Access Compliance Report

Public Rights-of-Way

Intersection ID: 11650	Main Street: W_10TH_ST	Cross Street: N_CHURCH_ST	Location: W
ADA ID: 5C8F5424FAC4	Ramp Type: PerpDiag	Initial Pass/Fail: Fail	Overall Compliance: No
			Severity Score: 33.75

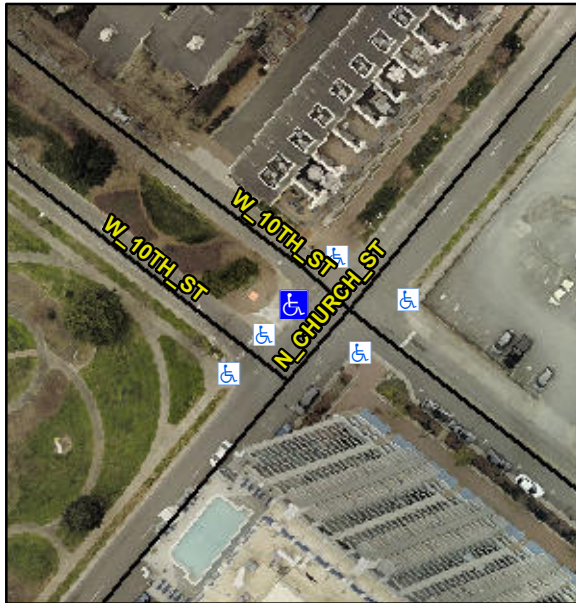
Not Found, R304.5.1, R304.2.2, R304.5.3

Compliance	Description	Data	Compliance	Description	Data
N/A	Ramp Length (in)	62.0	No	Ramp Slope (%)	9.4
No	Ramp Width (in)	41.0	No	Ramp XSlope (%)	6.2
N/A	Flare Type LT	N/A	N/A	Flare Type RT	N/A
N/A	Flare Slope LT (%)	N/A	N/A	Flare Slope RT (%)	N/A
N/A	Flare Traversable LT?	N/A	N/A	Flare Traversable RT?	N/A
N/A	Landing Length (in)	N/A	N/A	DWS Provided?	N/A
N/A	Landing Width (in)	N/A	N/A	DWS Contrast?	N/A
N/A	Landing Slope (%)	N/A	N/A	DWS Length (in)	N/A
N/A	Landing X Slope (%)	N/A	N/A	DWS Full Width?	N/A
N/A	Landing Curb? (Y/N)	N/A	N/A	DWS Offset (in)	N/A
N/A	Shared Landing?	N/A			
N/A	Gutter Ponding?	N/A	N/A	Gutter Slope (%)	N/A
N/A	Gutter Lip Ht (in)	N/A	N/A	Gutter X Slope (%)	N/A
N/A	Painted X Walk1?	No	N/A	Painted X Walk2?	No
	X Walk 1 Direction	To SE		X Walk 2 Direction	To NE
N/A	X Walk 1 Width (in)	N/A	N/A	X Walk 2 Width (in)	N/A
	X Walk 1 Slope (%)	4.3		X Walk 2 Slope (%)	2.1
	X Walk 1 X Slope (%)	2.8		X Walk 2 X Slope (%)	0.1

Remove & Replace Curb Ramp With Two New Directional Ramps or Equivalent.
